Addendum No. 3

RFT 25-055 - Washroom Renovation - Central Public School

CENTRAL PUBLIC SCHOOL WASHROOM AND STORAGE ROOM RENOVATIONS

ADDENDUM No. 3

AD11003

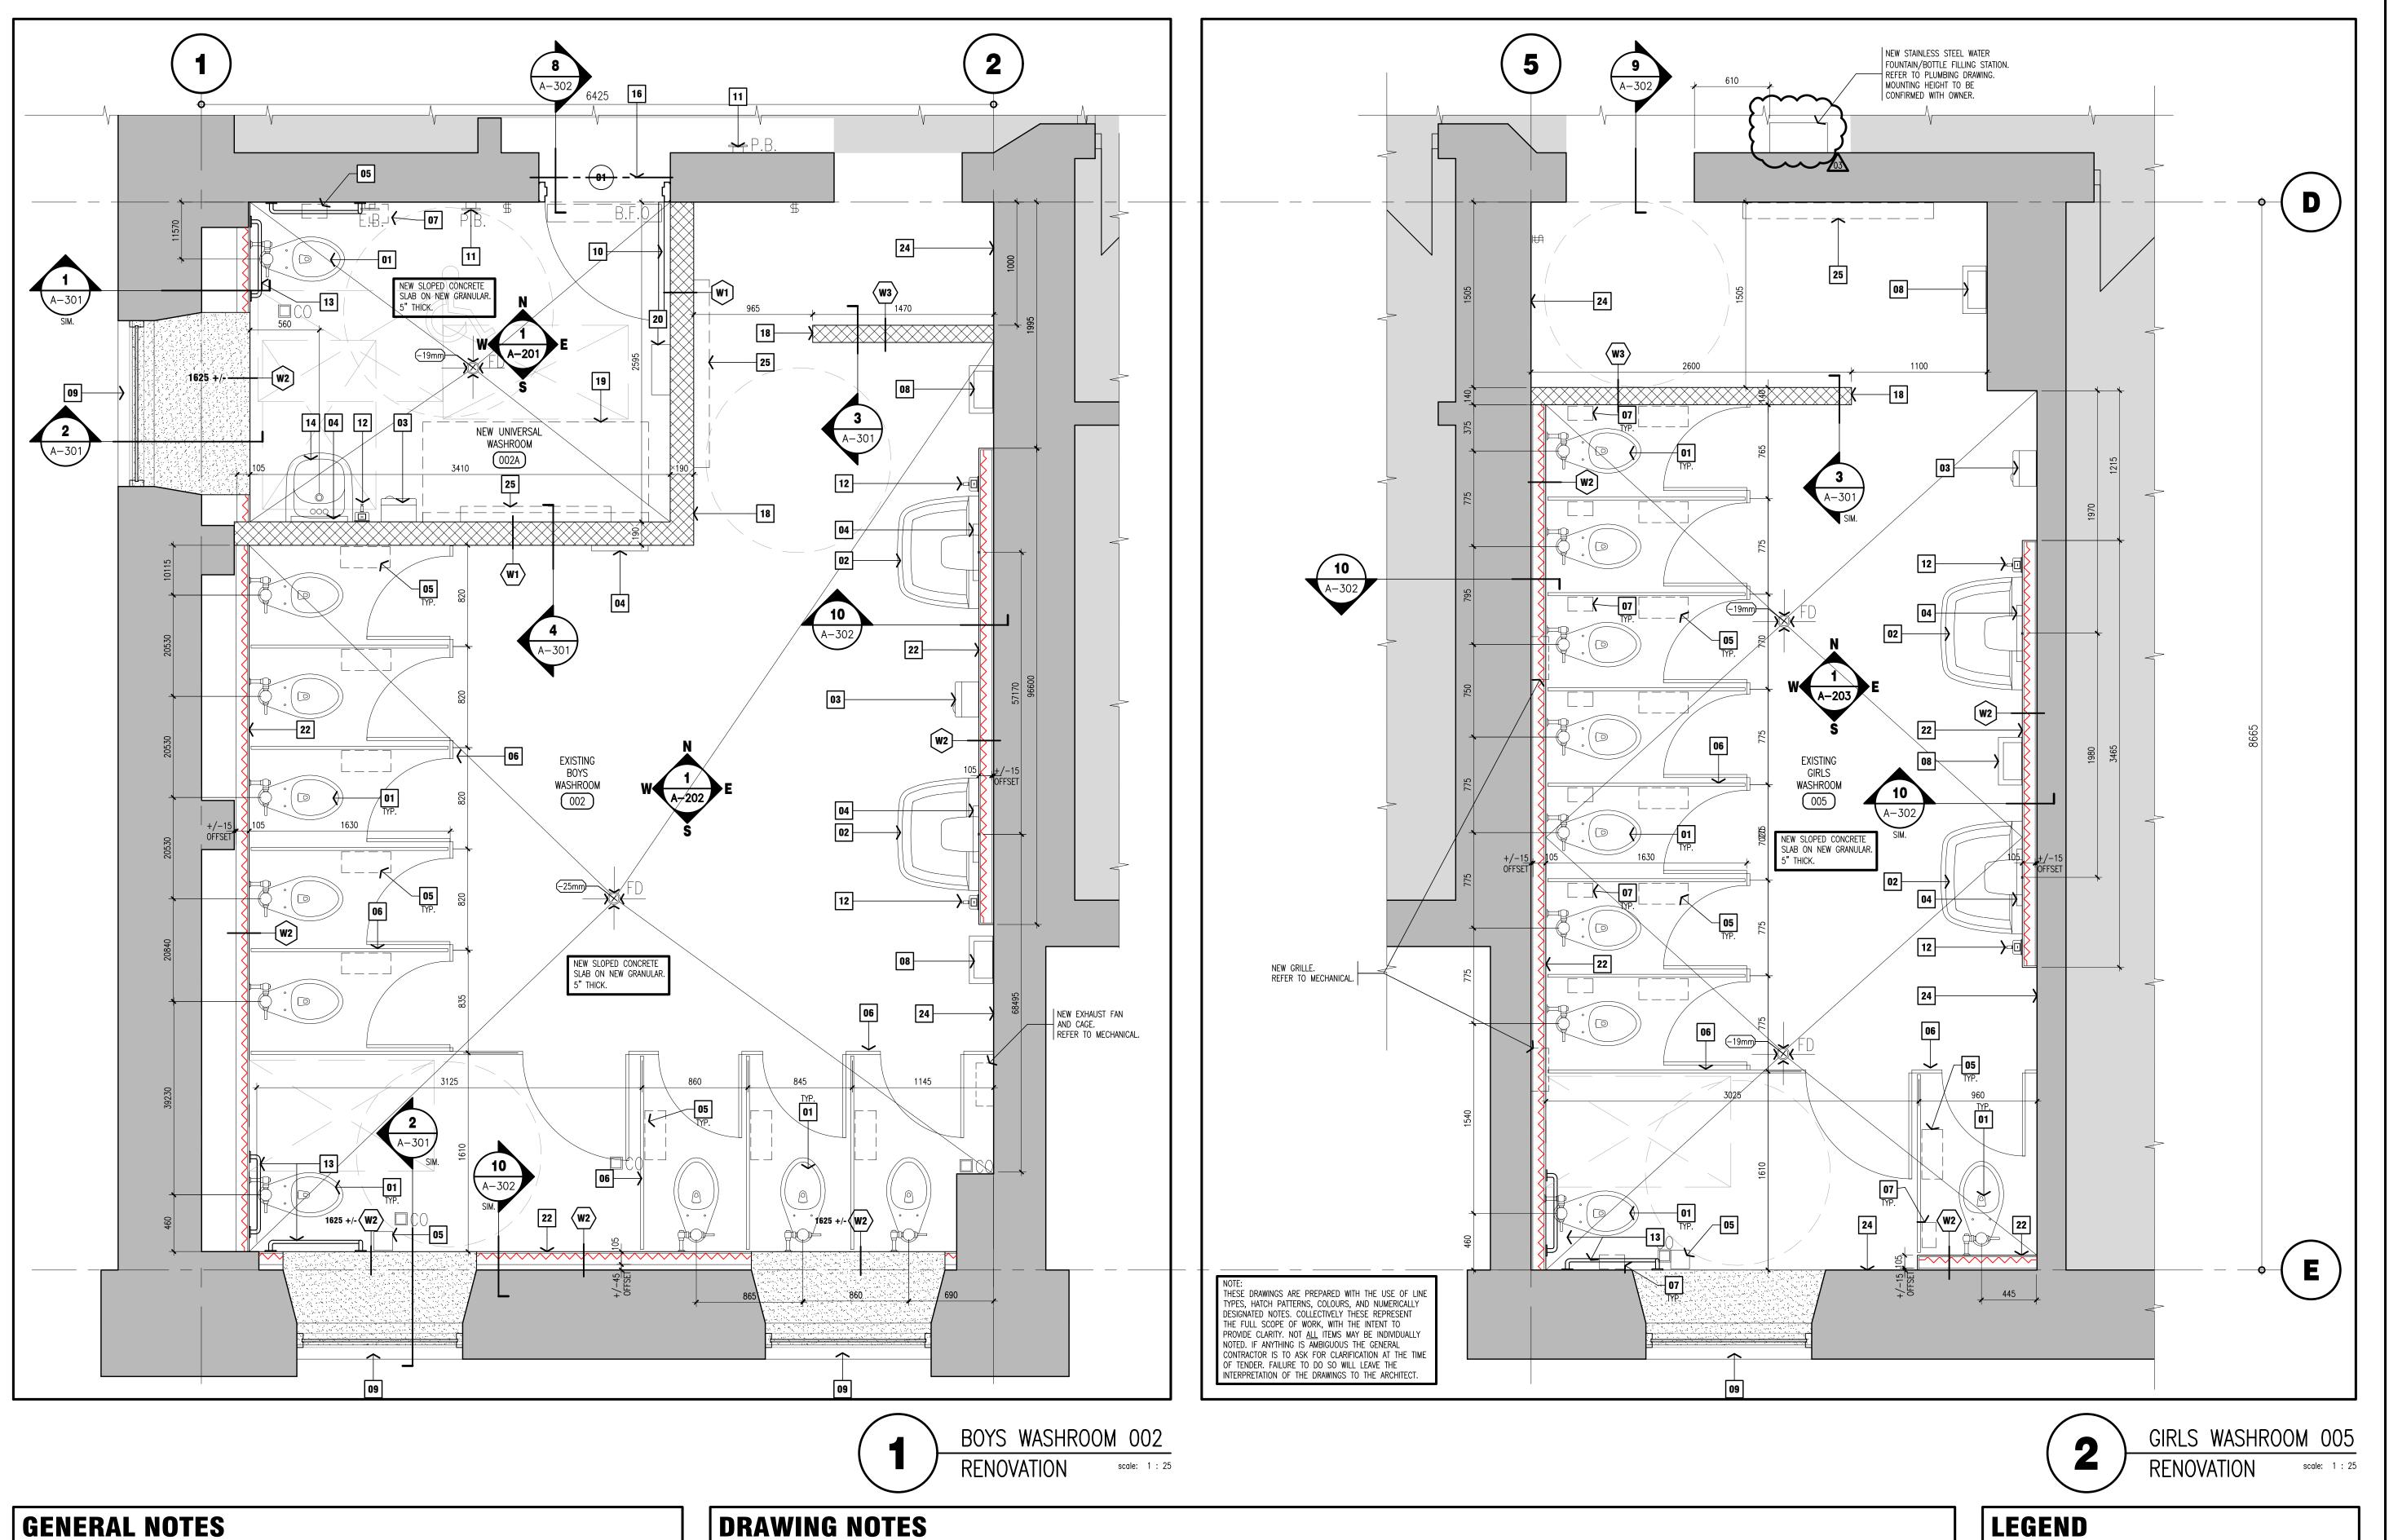
- Item 1.0 Drawing AD-110 'Boys and Girls Washroom Renovation Demolition Plans'
 - 1.1 Refer to attached revised Architectural Drawing AD-110(03) to replace previously issued drawing AD-110(02).

- 1.2 Existing water fountain outside of Boys Washroom is to be removed complete. Refer to plumbing drawings.
 - 1.3 GC is to patch, repair and make good existing wall areas that are affected by removal of existing water fountain and piping on this wall.

A - 30103

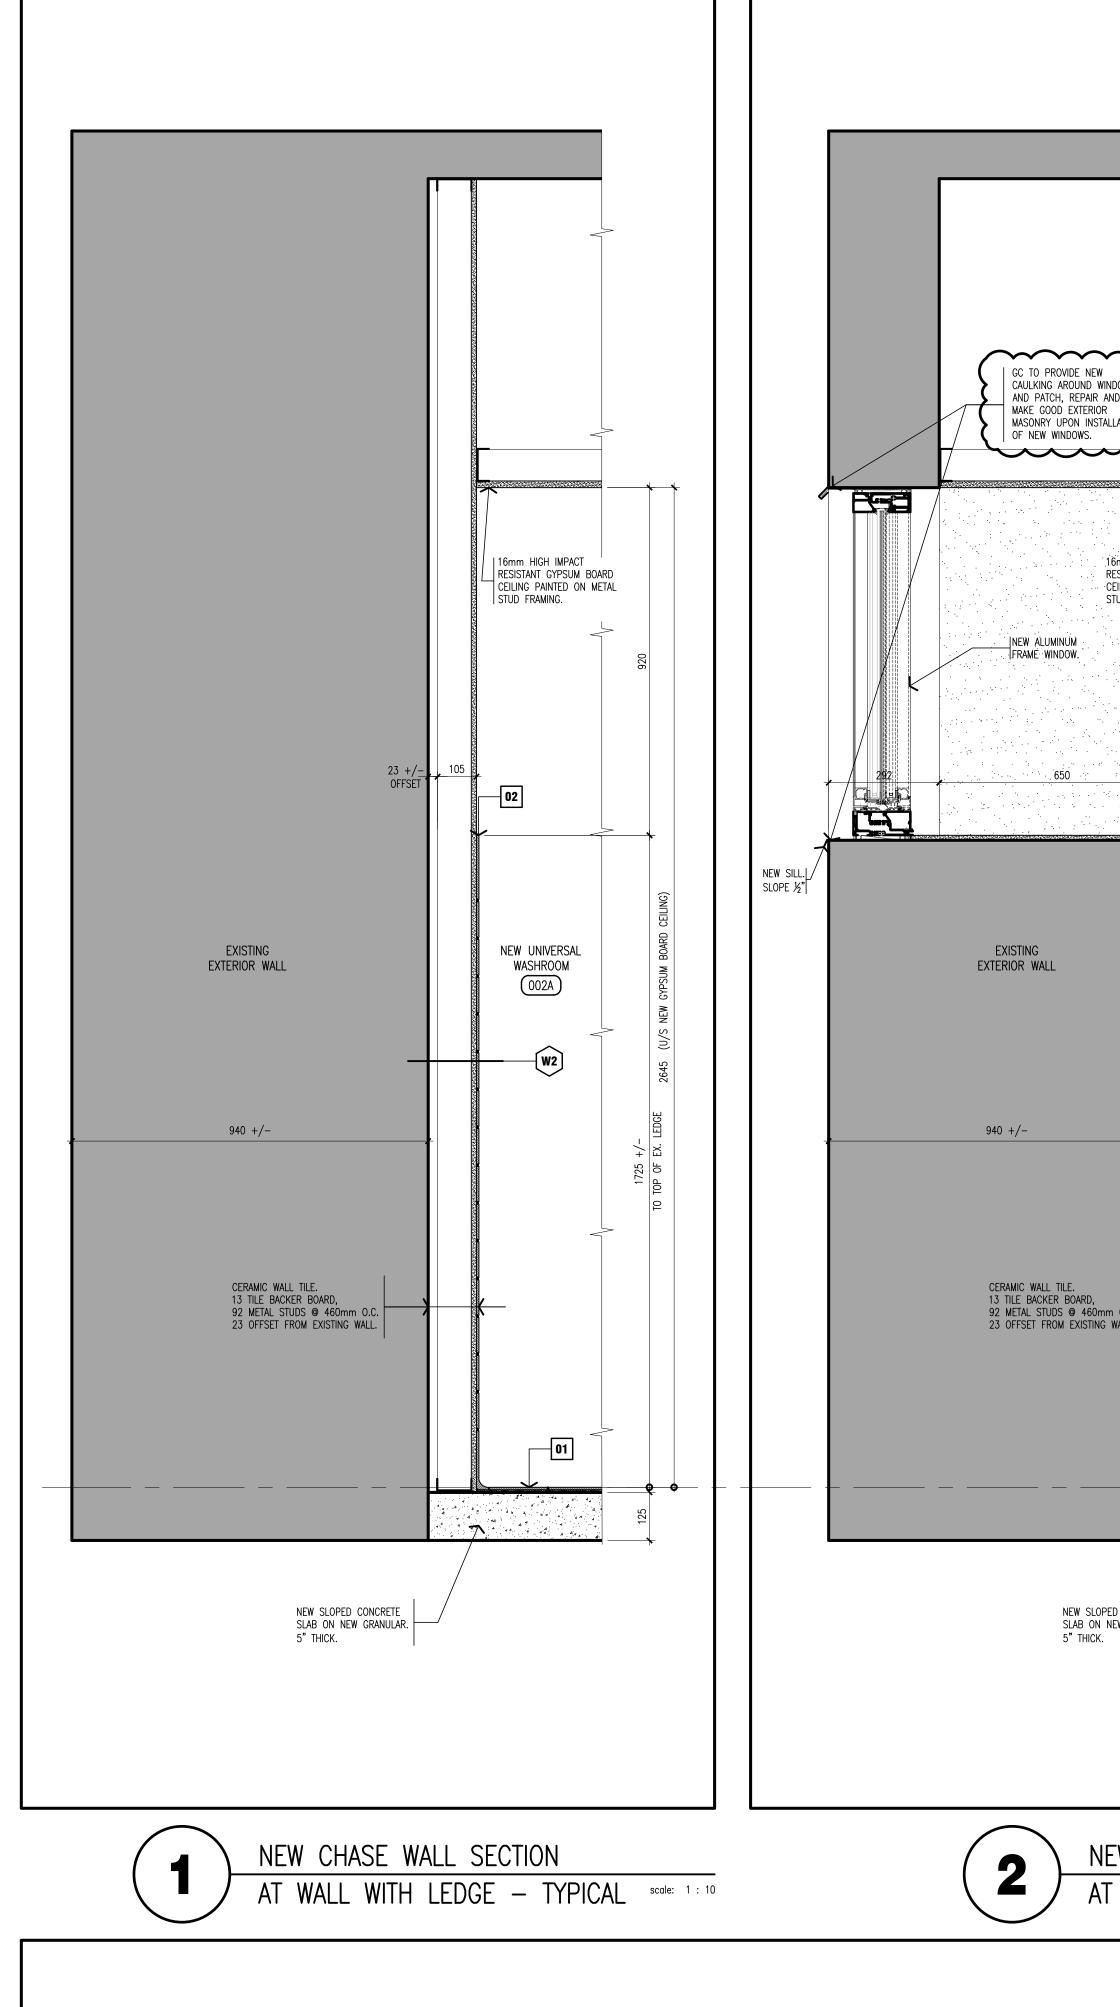
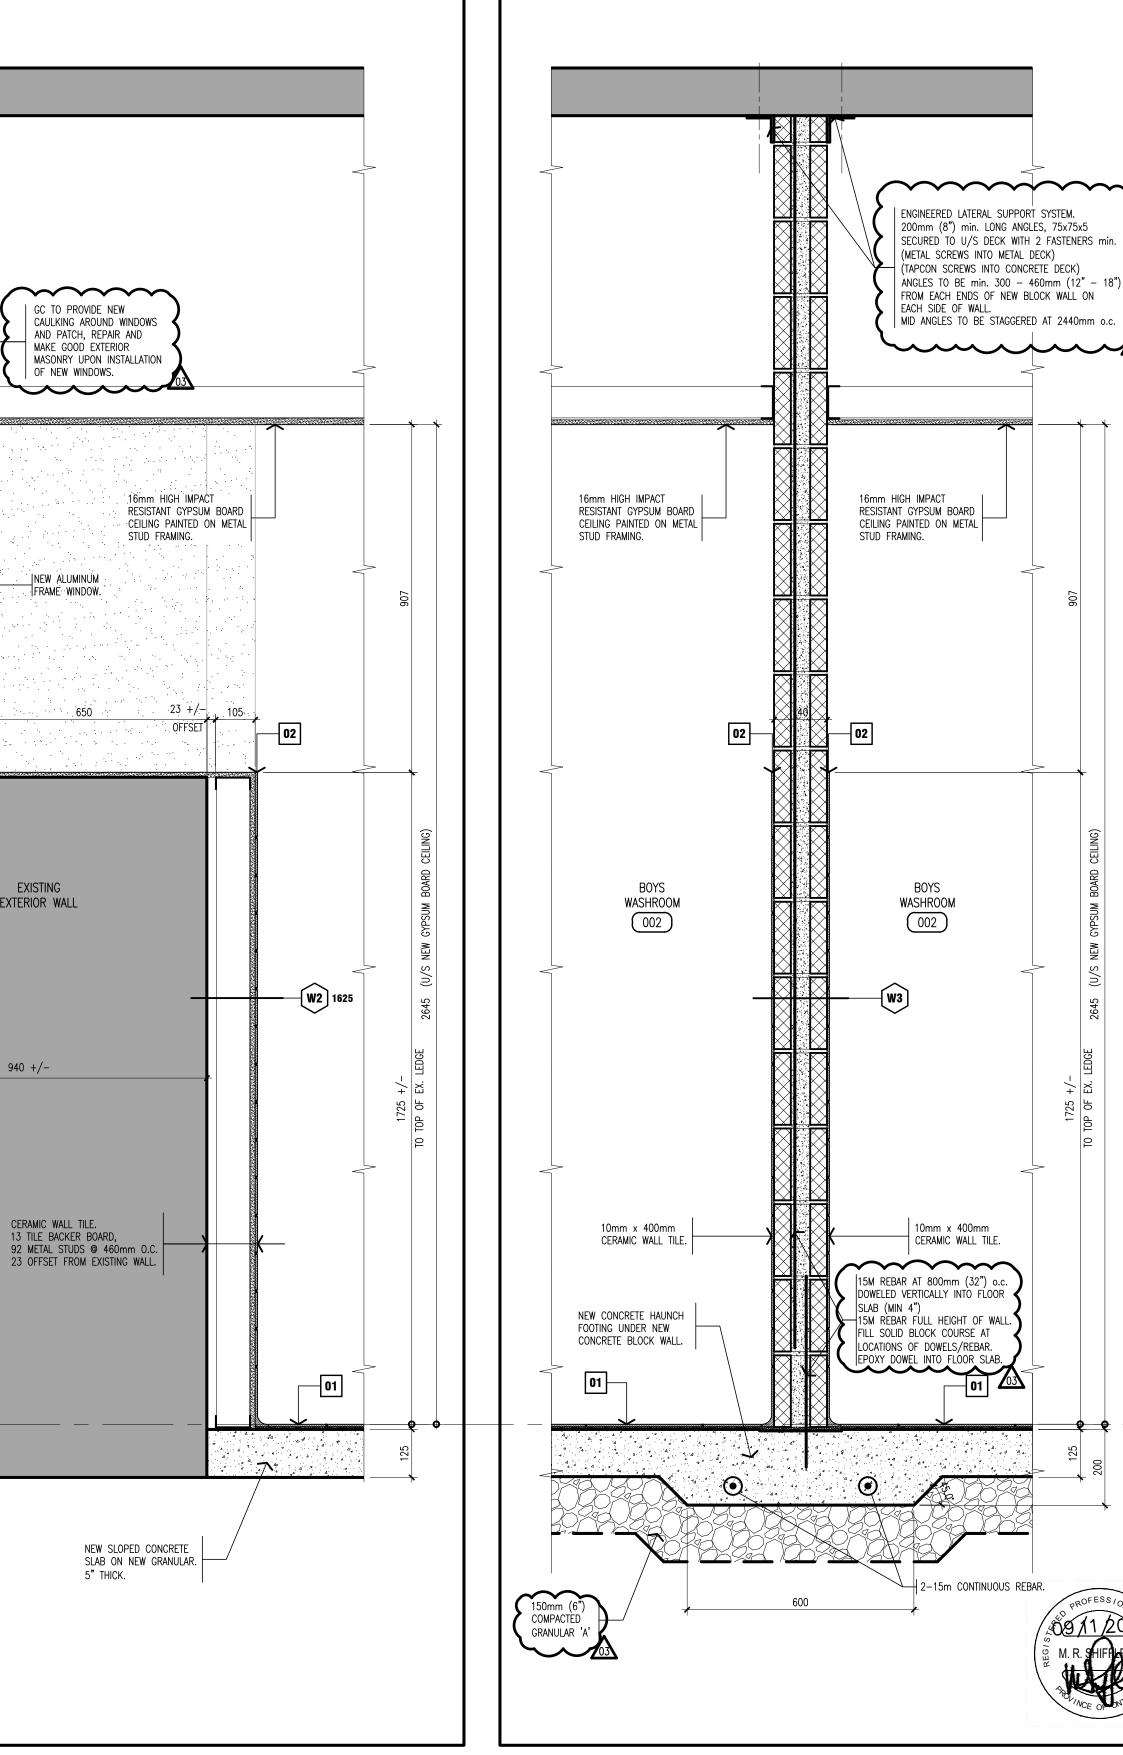
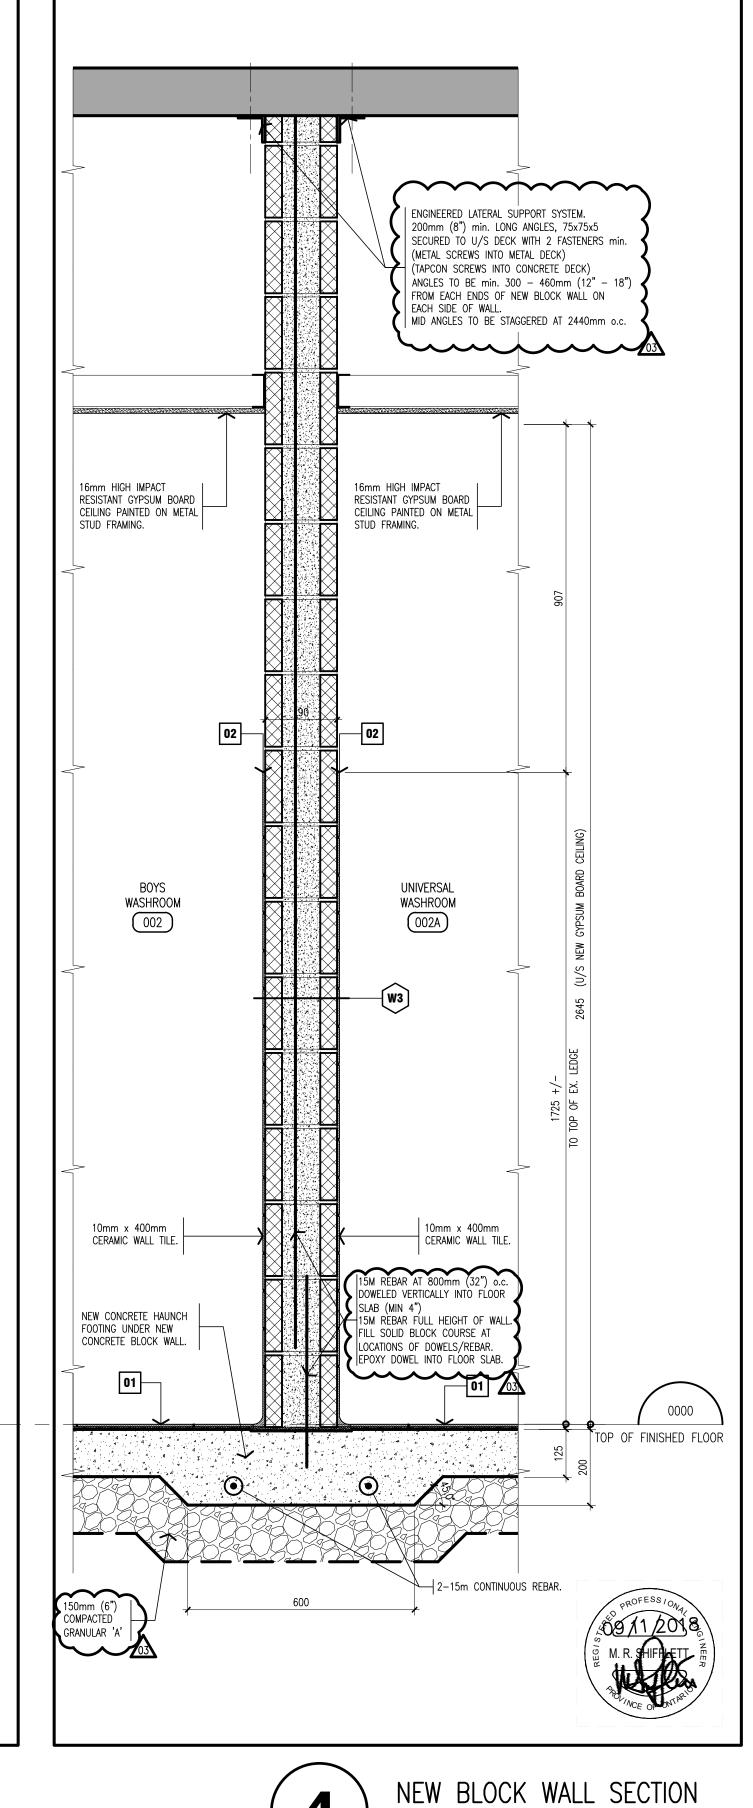
- 3.1 Refer to the attached revised Drawing A-301(03) to replace the previously issued drawings A-301.
 - 3.2 GC to ensure new window in Universal washroom accommodates the new fan. Refer to Mechanical Drawings for sizing and details. GC is to coordinate location and sizing of opening for fan.
